This notice is sent to you in accordance with the requirements of the National Traffic and Motor Vehicle Safety Act.

### CAMPAIGN BULLETIN

### 01-593-11

SUBJECT: Miller "D" lanyard anchor p/n 472452

Date code

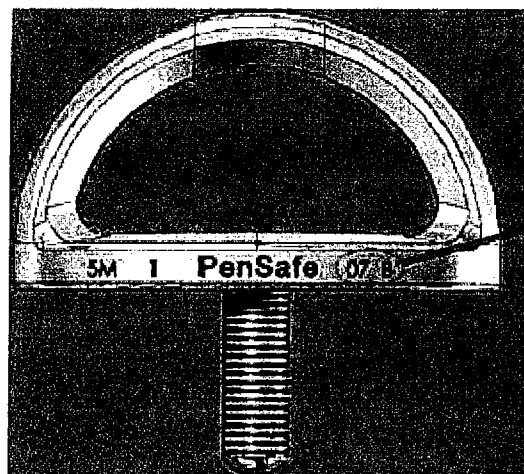
TEREX Utilities has received notice of a recall from the supplier of the D shaped lanyard anchor, p/n 472452 with the date code 07B. There is a deficiency in the material strength that may cause the threads on the stem to fracture prematurely. These parts could be on machines built from June, 2008 through November, 2010.

**During a fall arrest event the D shaped lanyard anchor can fail.**

Immediately inspect the lanyard anchors on units listed in the attached letter for lanyard anchors having the date code 07B, as shown below. Immediately take the unit out of service if the date code appears. If the date code does not appear, simply complete the enclosed form to complete this bulletin.

If your lanyard anchor is affected, call TEREX Utilities, at 605-884-3892 for a replacement kit, p/n Z-1200. Follow the installation instructions that accompany the kit. Complete the enclosed form and return it with the affected anchor to TEREX Utilities, using the shipping label and shipping box, for credit.
